LINOTYPE IMPROVEMENT SHEET

NO. 314

TELETYPESETTER DELAY STARTING SWITCH ATTACHMENT F-8914

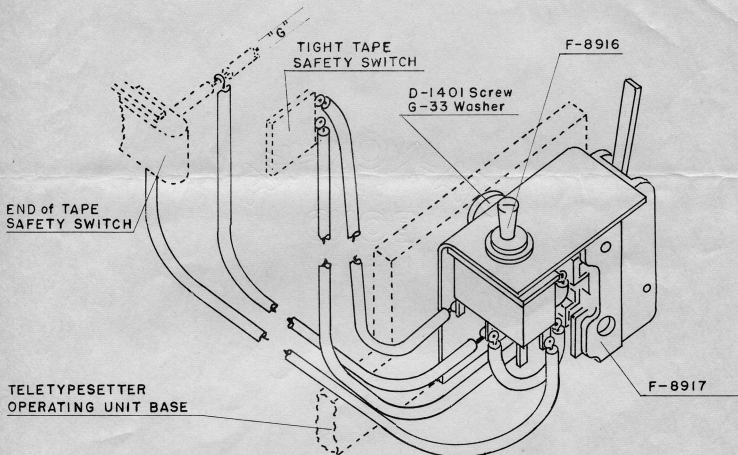
A Teletypesetter Delay Starting Switch Assembly (F-8914) has been designed, which has the function of delaying the Teletypesetter Operating Unit for a sufficient period of time between each line to permit matrices to be redistributed to the Magazine. Switch (F-8914) accomplishes this delay by stopping the operating unit after each line until the line delivery returns to normal position. This is especially desirable when setting long line lengths of (16) Picas or over by Teletypesetter since it insures sufficient matrices being in the Magazine for the proper assembly of the next line.

Can be applied to all Comets equipped with Comet Teletypesetter Operating Unit having Stop Magnets. Use Mailing Sheet #641.
